Permit #	Deficiency ExteNet Must Correct	Public Works Inspection Photograph	ExteNet Simulation	ExteNet Plans
1680 Powell St. / 14WR-0017	A disconnect switch was installed that is larger than the switch approved in the plans/sims			
826 Vallejo St. / 14WR-0026	A disconnect switch was installed that is larger than the switch approved in the plans/sims			
539 Francisco St. / 14WR-0034	A disconnect switch was installed that is larger than the switch approved in the plans/sims

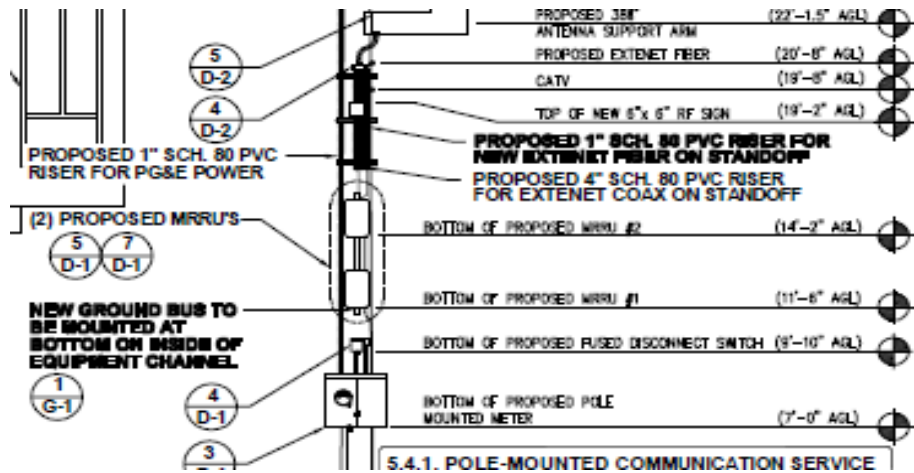
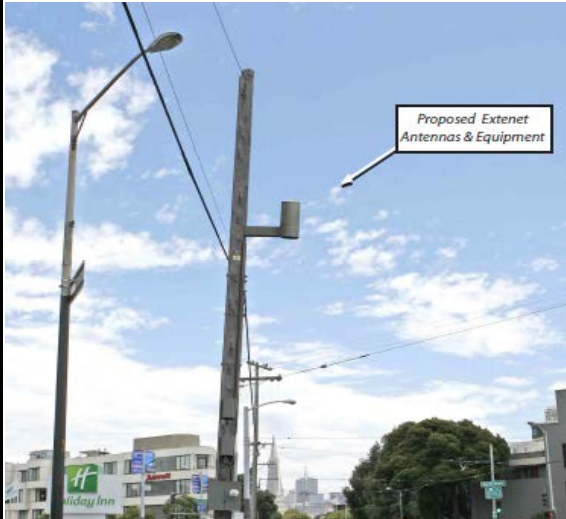
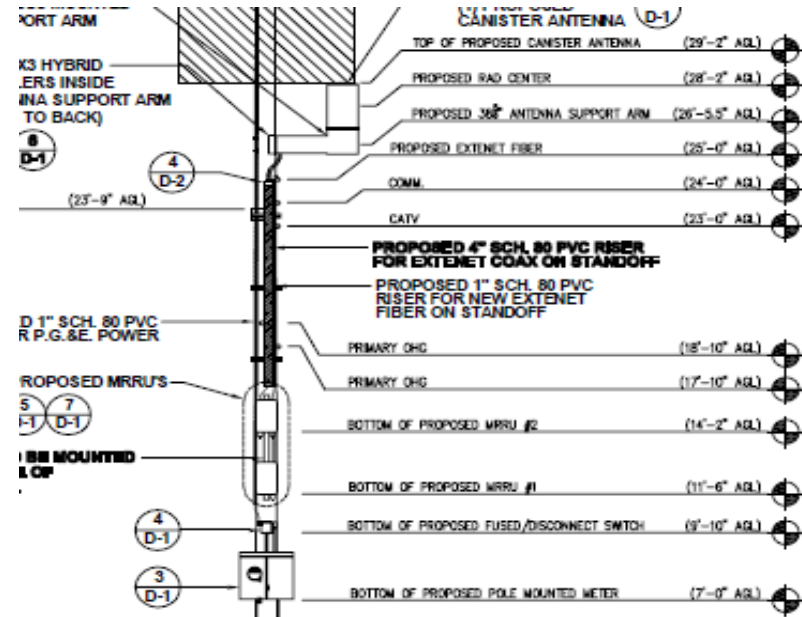
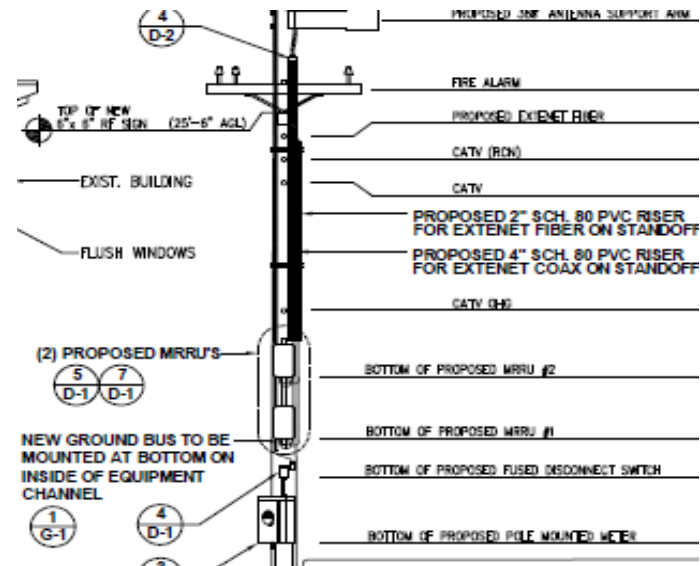
Permit #	Deficiency ExteNet Must Correct	Public Works Inspection Photograph	ExteNet Simulation	ExteNet Plans
759 Chestnut St. /14WR-0039	<p>The plans and sims indicate that the antenna should have been centered on the pole. However, the antenna was not centered and a large bolt is visible at the base of the antenna that was not shown in the plans and sims. Additionally, the installed antenna looks like a different model than what was shown on the plans and sims. Moreover, it appears that the MRRU, disconnect switch, and meter are installed on the eastern side of the pole, but the sims and plans indicate this equipment was proposed on the western side of the pole. Furthermore, a disconnect switch was installed that is larger than the switch approved in the plans/sims. [Regarding the inspector's comments, the permit was approved with a vertical antenna; the previous design was a horizontal antenna.]</p>

2460 Polk St. / 14WR-0042	<p>Per plans and sims, the MRRUs, disconnect switch, and meter were supposed to be installed on the eastern side of pole. However, they were all installed on the western side of the pole. Additionally, a disconnect switch was installed that is larger than the switch approved in the plans/sims</p>

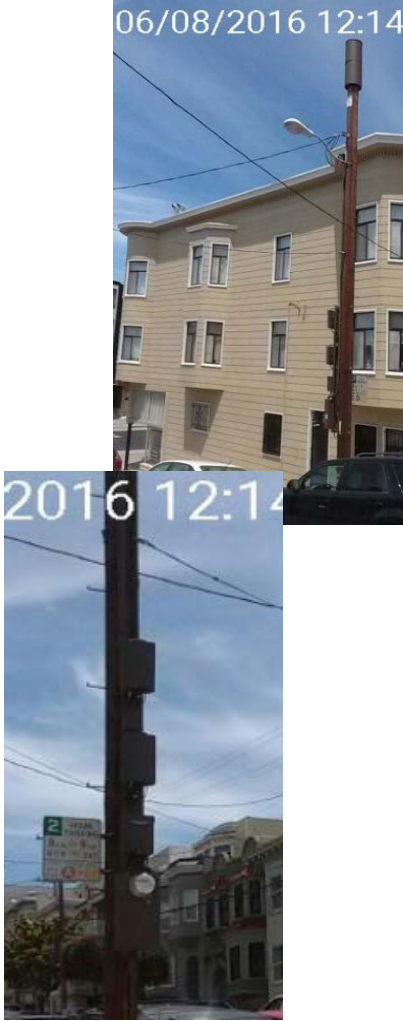
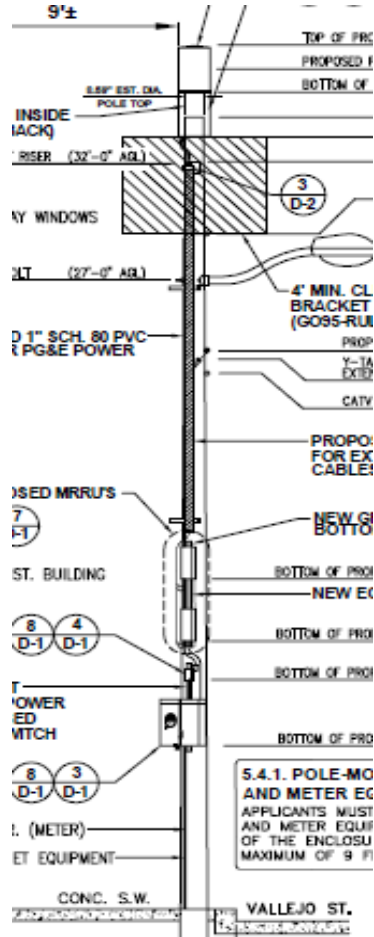
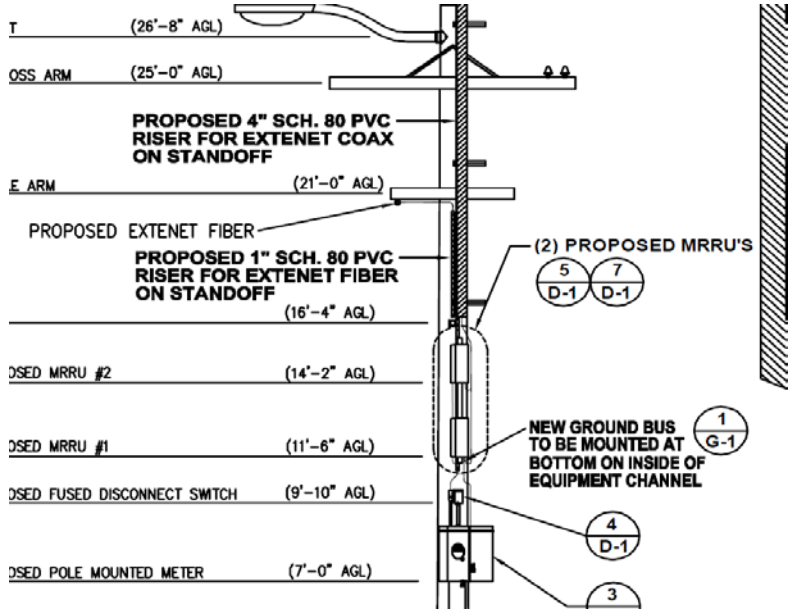
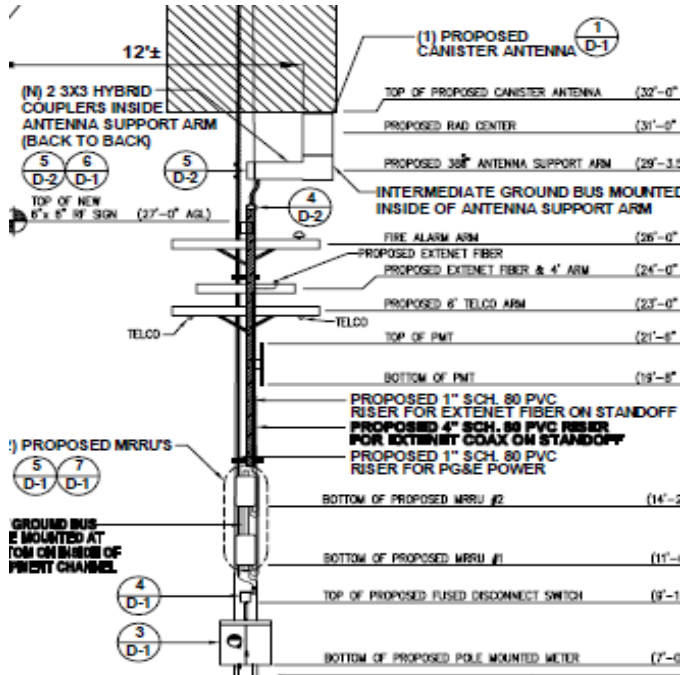
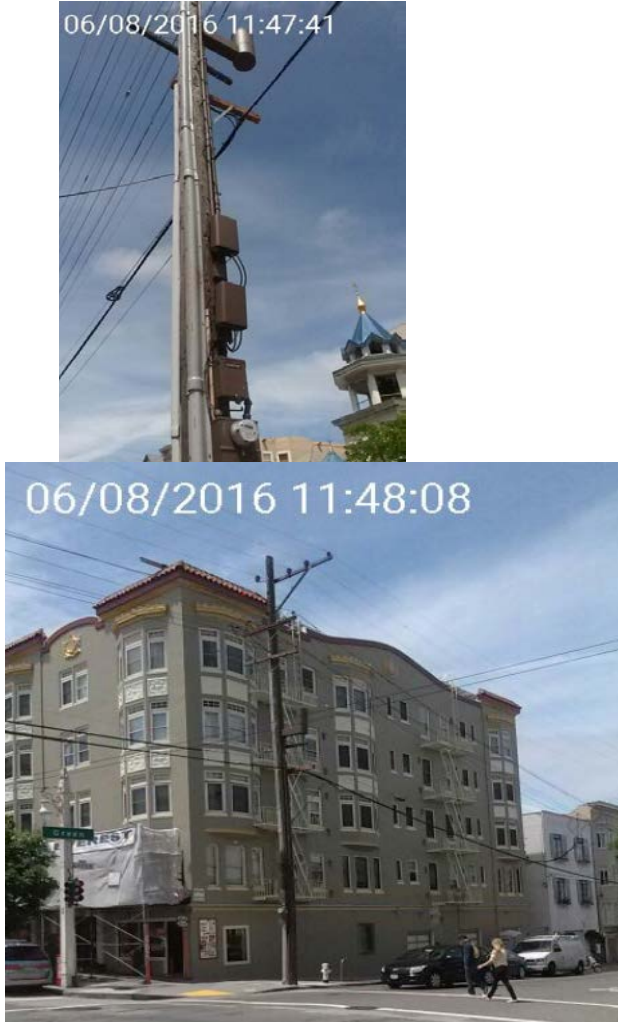
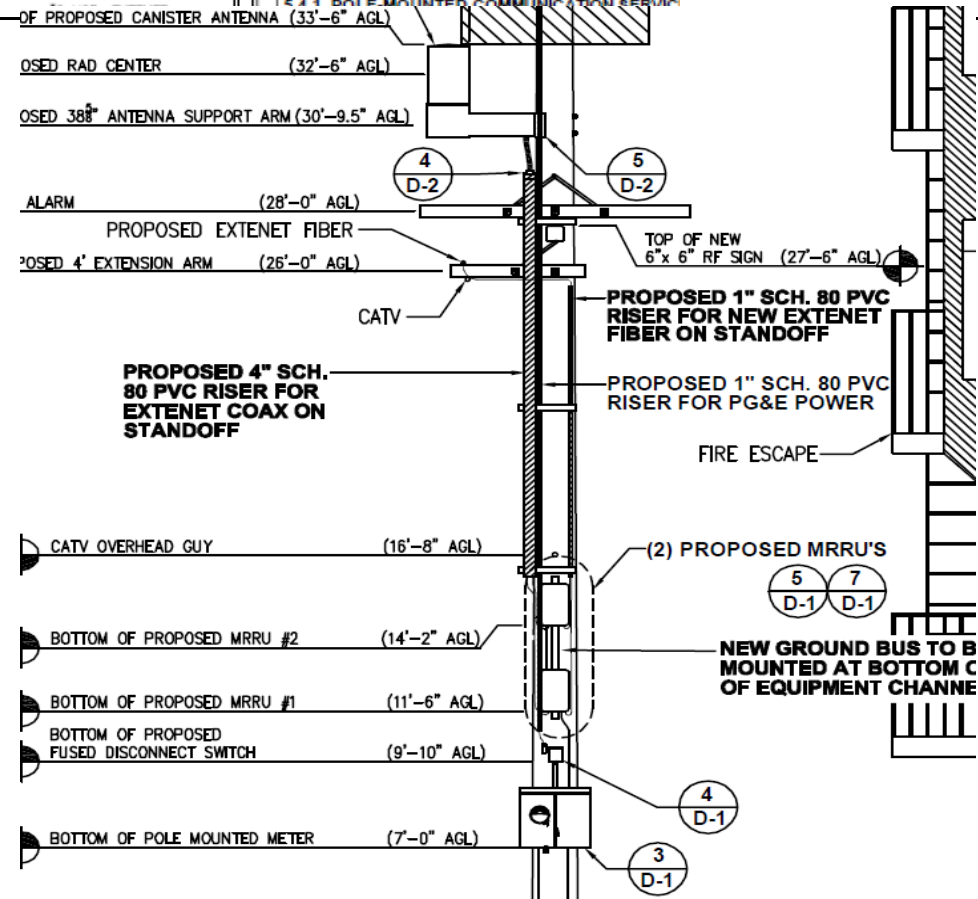
Permit #	Deficiency ExteNet Must Correct	Public Works Inspection Photograph	ExteNet Simulation	ExteNet Plans
1294 Vallejo St. / 14WR-0044	A disconnect switch was installed that is larger than the switch approved in the plans/sims			
1154 Filbert St. / 14WR-0050	A large bolt is visible at the base of the antenna that was not shown in the plans and sims. Additionally, the installed antenna looks like a different model than what was shown on the plans and sims. Furthermore, a disconnect switch was installed that is larger than the switch approved in the plans/sims

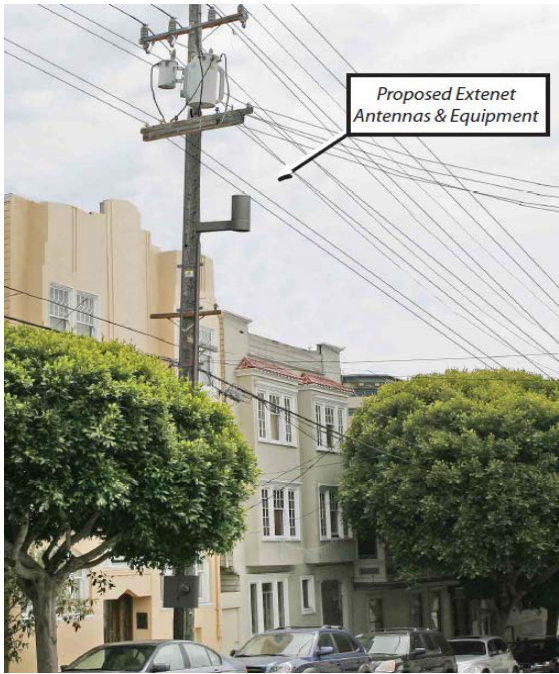
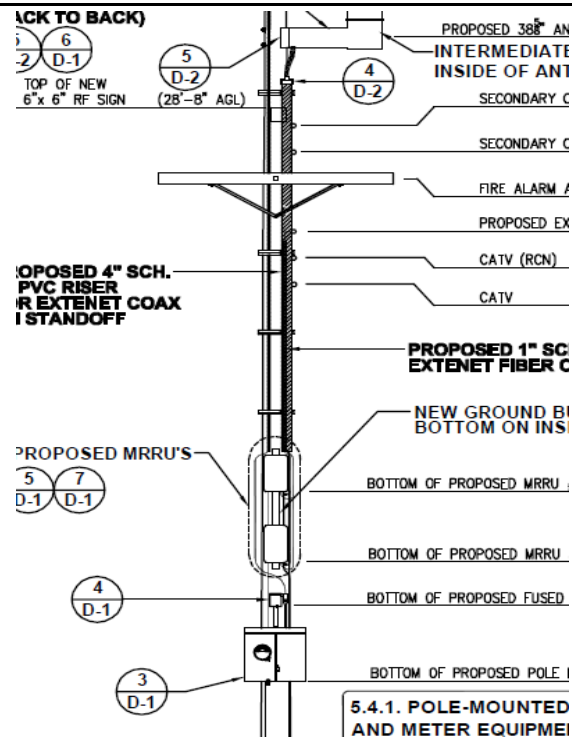
Permit #	Deficiency ExteNet Must Correct	Public Works Inspection Photograph	ExteNet Simulation	ExteNet Plans
1590 Washington St. / 14WR-0056	A disconnect switch was installed that is larger than the switch approved in the plans/sims. Additionally, the sims and plans indicate the pole would have 3 arms after construction. However, the pole only has 2 arms.			
169 Willow St. / 14WR-0063	A disconnect switch was installed that is larger than the switch approved in the plans/sims
